EEI Comments to EPA on EVSE Draft 2 Test Method

The Edison Electric Institute (EEI) appreciates the opportunity to submit comments on the Draft 2 Test Method (Rev. Oct-2015) and the October 21, 2015 webinar slides addressing the test methods for electric vehicle supply equipment (EVSE).

Data Assembly Process (cont'd)

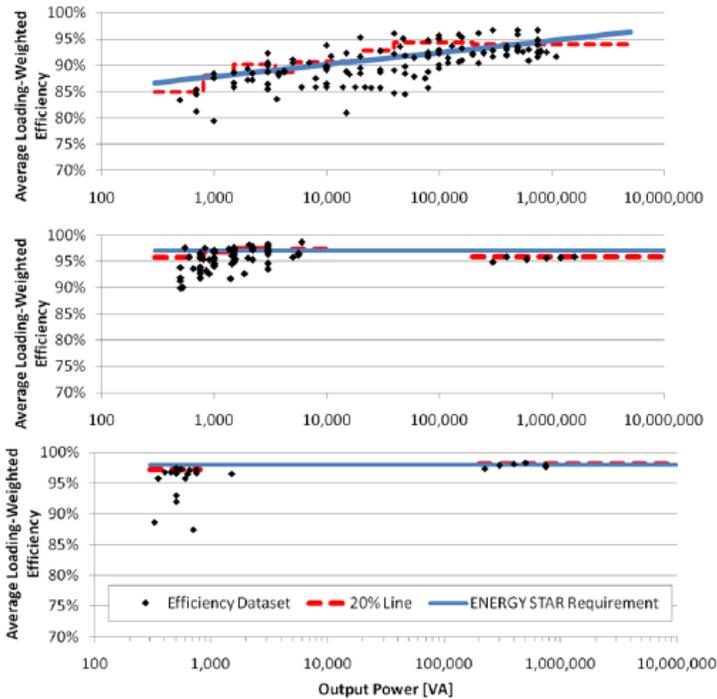
On the webinar slides 51 through 54, EPA provided graphs to show the efficiency at 25% load by EVSE type (VFD, VI, and VFI) and average loading-weighted efficiency. On slide 54, there is information about the “20% line” (EEI assumes that 20% of the tested products are at or higher than that efficiency), and a preliminary Energy Star requirement. In reviewing the slides for the VI and VFD products, however, it appears from the graphs that the number of models that would qualify in each of these two categories is much lower than 20%, especially at higher output power values:

Therefore, if EPA is going to rely on this information as the key determinant for an Energy Star EVSE, EEI would request that EPA revise its draft specification to ensure that there is a significant choice of models and manufacturers in each of the three categories. Neither customers, nor the marketplace, are well served by such a disproportionately limited selection of options for one or more of the categories.
